[Docket No. FAA–2009–0218; Directorate Identifier 2009–CE–006–AD]

Airworthiness Directives; Piper Aircraft, Inc. PA–23, PA–31, and PA–42 Airplanes

ACTION: Notice of proposed rulemaking (NPRM).

Figure 1. – Nose Baggage Door Placard.

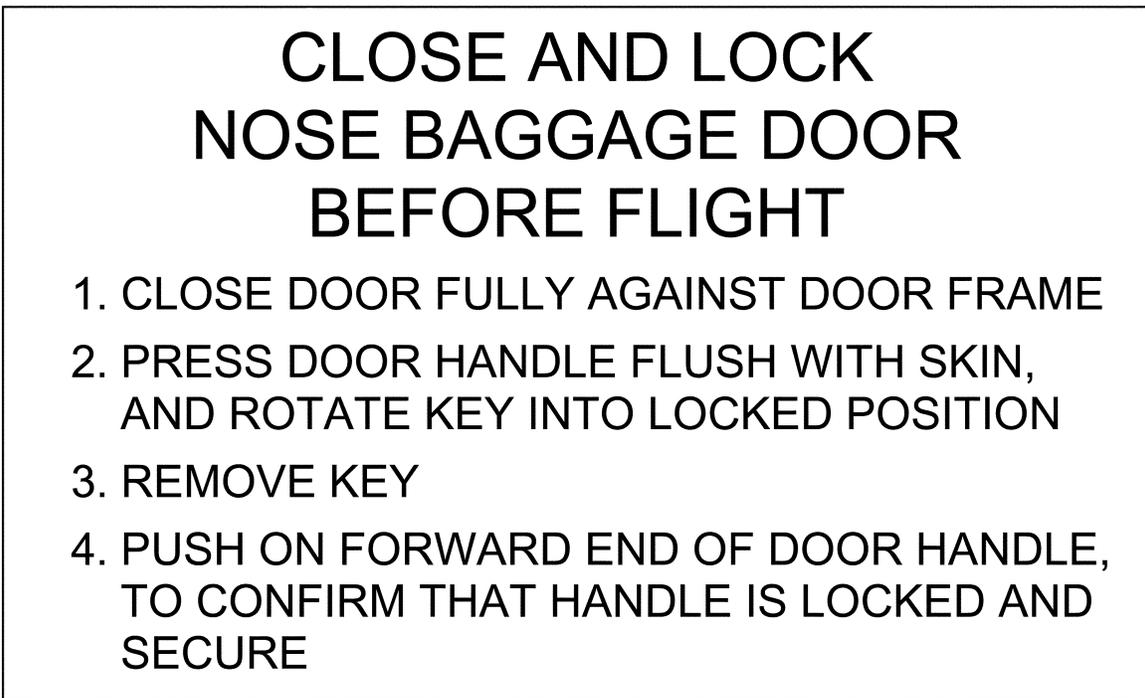
| Actions | Compliance | Procedures |
|--|---|--|
| <p>(1) For all aircraft:</p> <ul style="list-style-type: none"> (i) Inspect the nose baggage door assembly for damaged, worn, corroded, or non-conforming components; (ii) Replace life-limited components specified in the service information; and (iii) Install or inspect, as applicable, the nose baggage placard following the service information. | <p>Initially within 1,000 hours time-in-service (TIS) since all life-limited components were installed new following Piper Aircraft, Inc. Mandatory Service Bulletin No. 1194A, dated November 10, 2008, or within the next 100 hours TIS after July 24, 2009 (the effective date retained from AD 2009-13-06), whichever occurs later. Repetitively thereafter at intervals not to exceed 1,000 hours TIS.</p> | <p>Follow INSTRUCTIONS: PART I of Piper Aircraft, Inc. Mandatory Service Bulletin No. 1194A, dated November 10, 2008. As an alternative to using part number 100700-079 placard, you may fabricate a placard (using at least 1/8-inch letters) with the words in figure 1 of this AD and install the placard directly above the nose baggage door handle. This AD does not require verification of proper functioning of the nose baggage compartment interior light as stated in the last sentence of PART 1, paragraph 1, of Piper Aircraft, Inc. Mandatory Service Bulletin No. 1194A, dated November 10, 2008.</p> |
